Director's Report

Project Name: Comfort Care White Lake
 Description: Rezoning & Preliminary Site Plan Approval
 Date on Agenda this packet pertains to: May 19th, 2022

RE: Comfort Care Assisted Living- Preliminary Site Plan Review – 4th Review

RE: Comfort Care
Rezoning and Preliminary Site Plan – Review #4

PROJECT NUMBER	210303	SHEET	C200
PROJECT PHASE	SPA

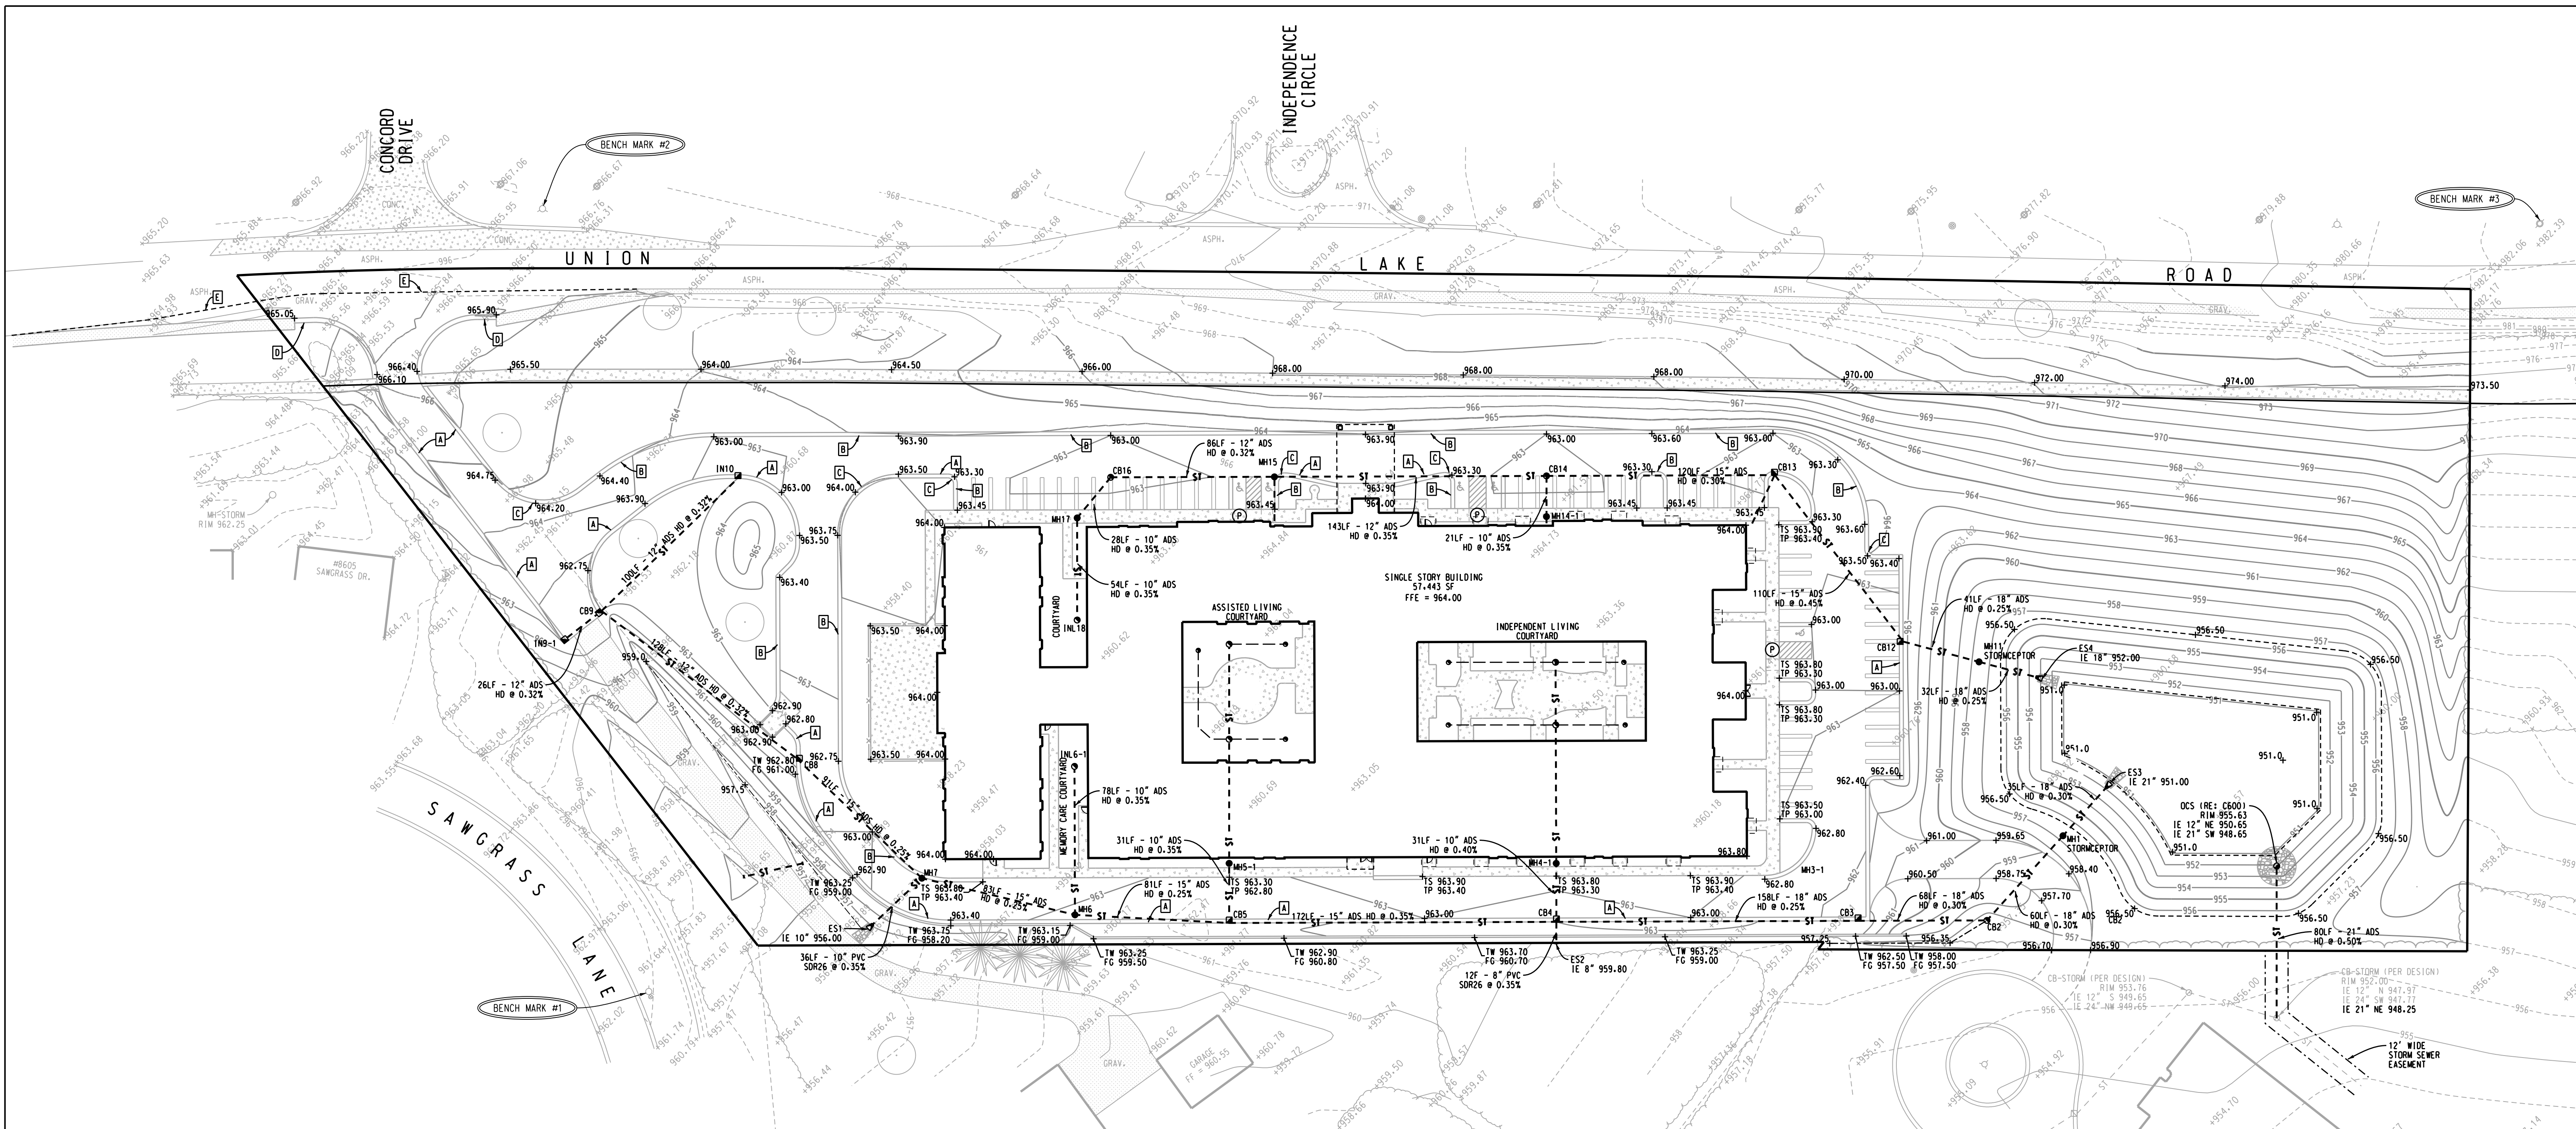
An updated list of all requested waivers shall be provided on Sheet C200 of the site plan.

PROJECT NUMBER	210303	SHEET	C400
PROJECT PHASE	SPA

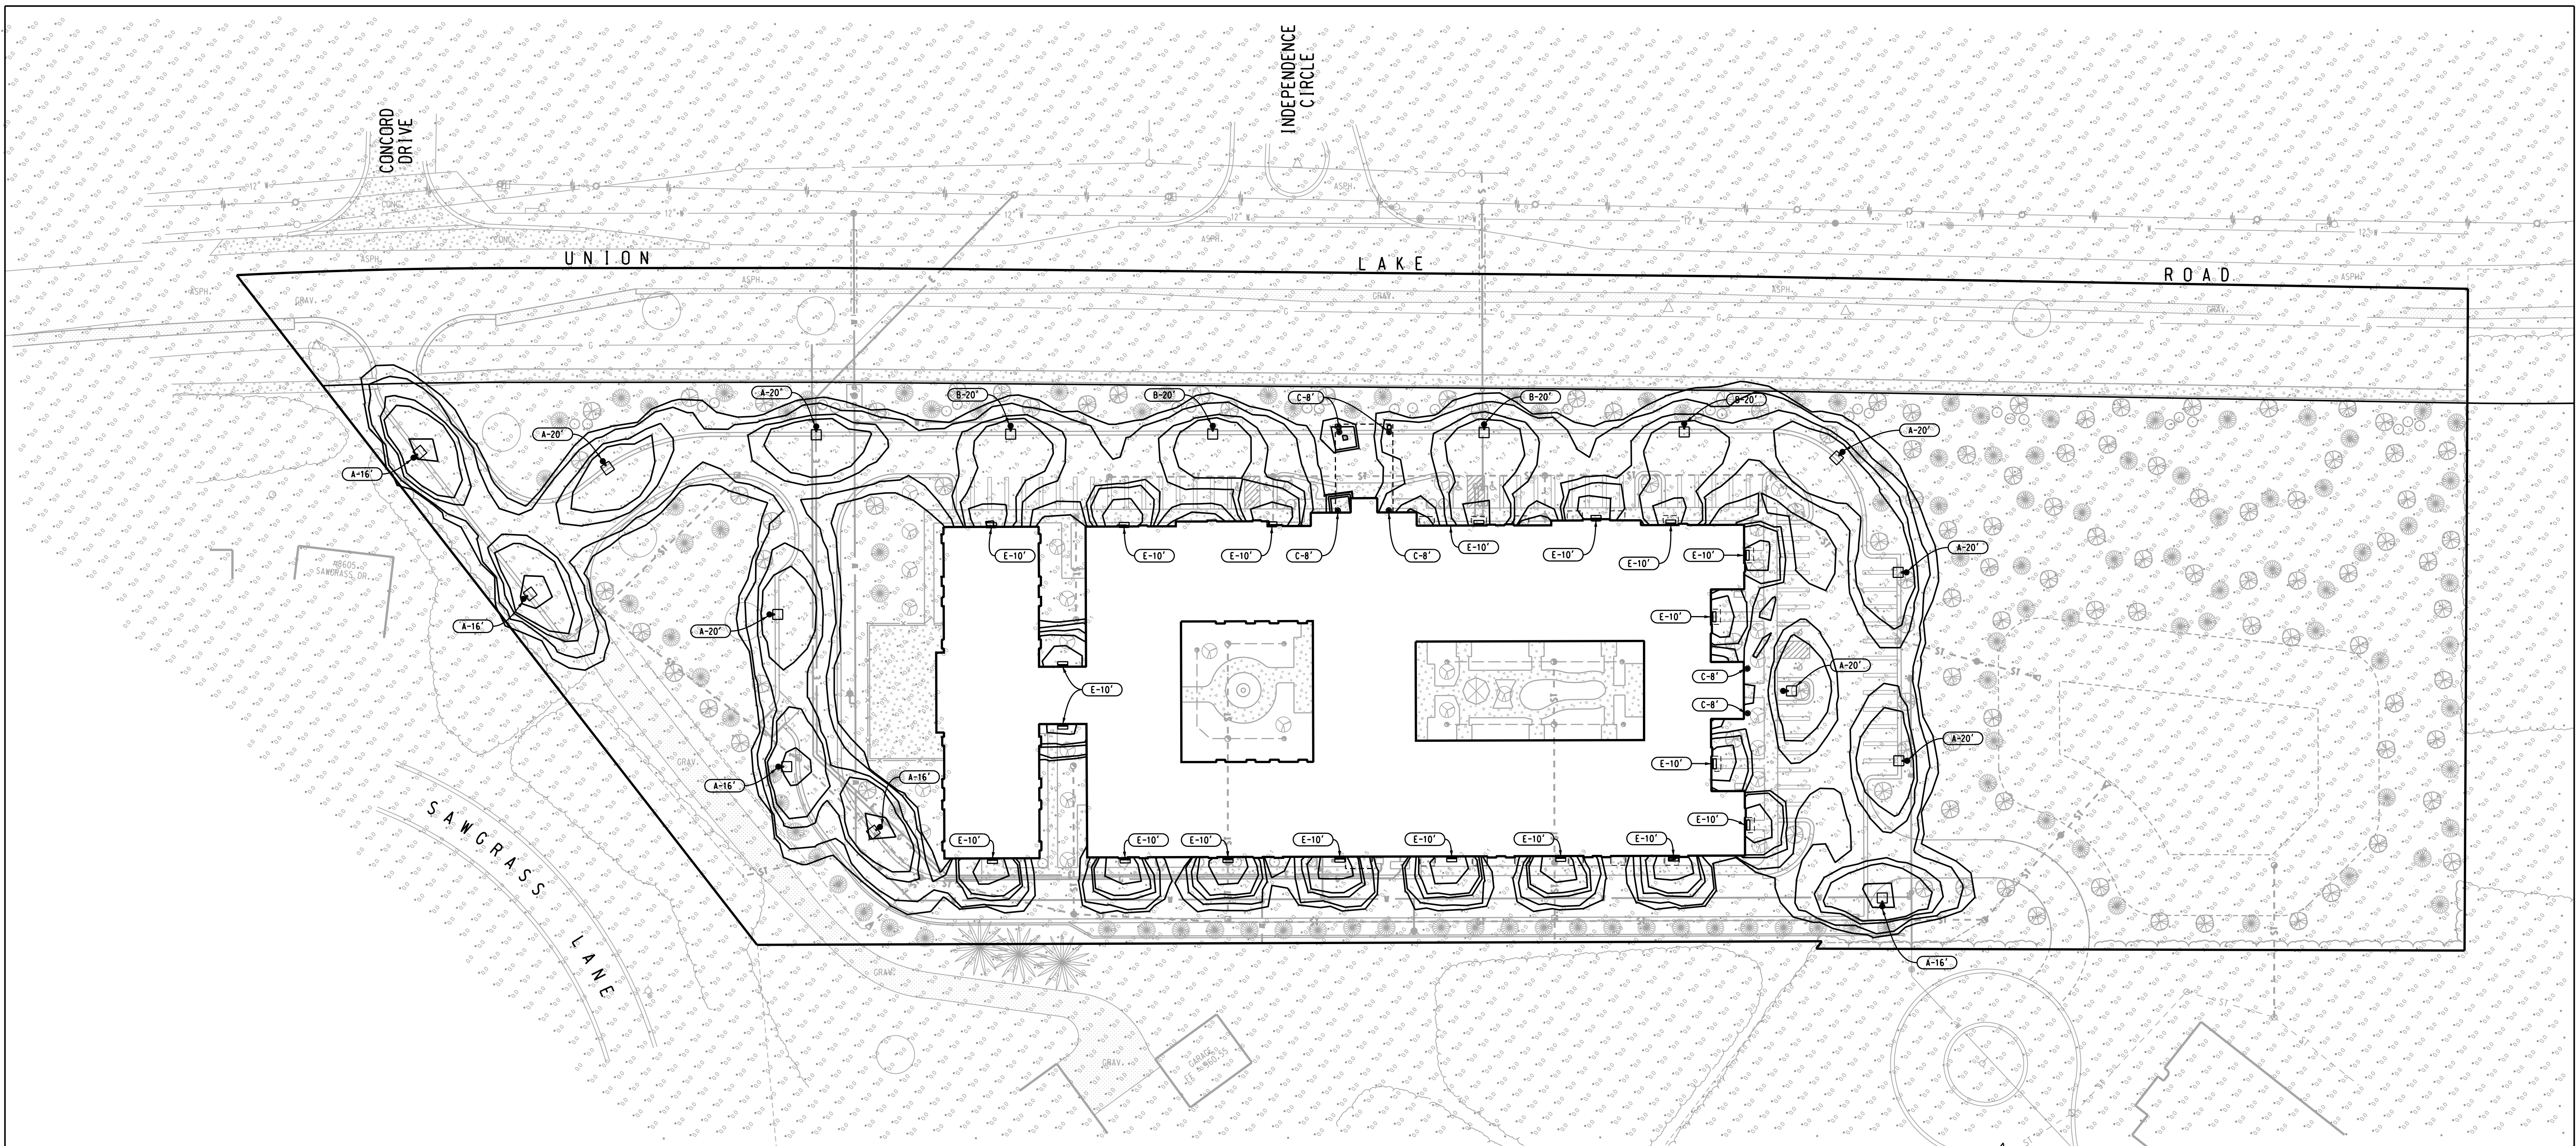
1. *We defer to the Fire Department regarding items related to fire suppression and hydrant coverage.* **Comment remains as a notation.**
 2. *Remove all references to Genessee County on the water main notes on Sheet C400- Site Utility Plan. Note that all notes regarding proposed utilities shall be per White Lake Township standards.* **Comment addressed.**
-
